SPINDLE WITH R8 COLLET

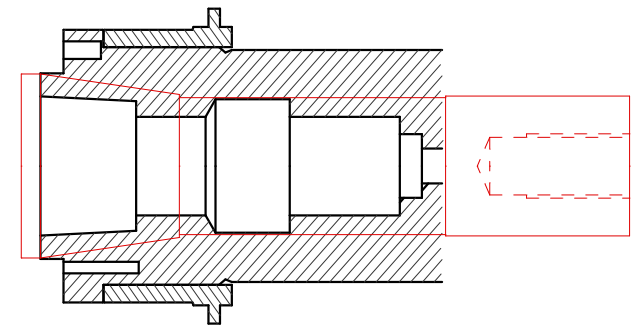
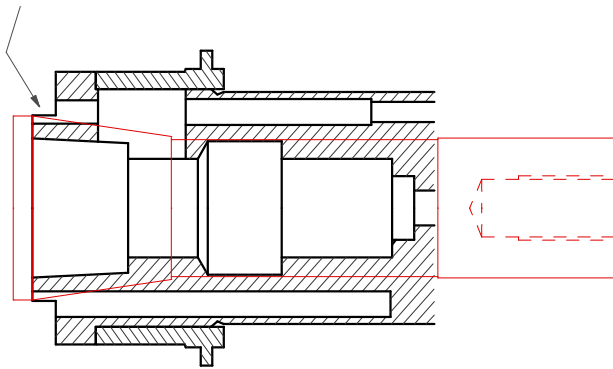
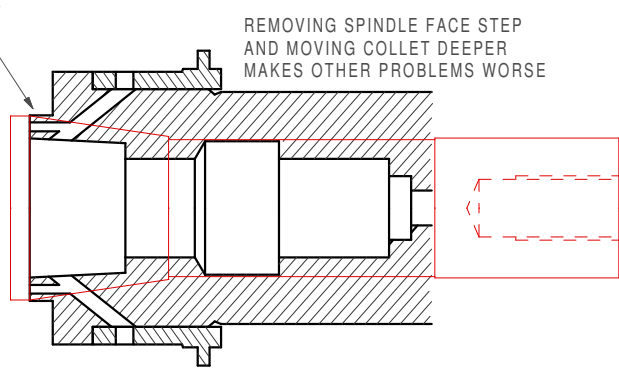
NOT ENOUGH METAL LEFT FOR SUPPORT

REMOVING SPINDLE FACE STEP
AND MOVING COLLET DEEPER
MAKES OTHER PROBLEMS WORSE

TAPER INTERSECTS PIN HOLE
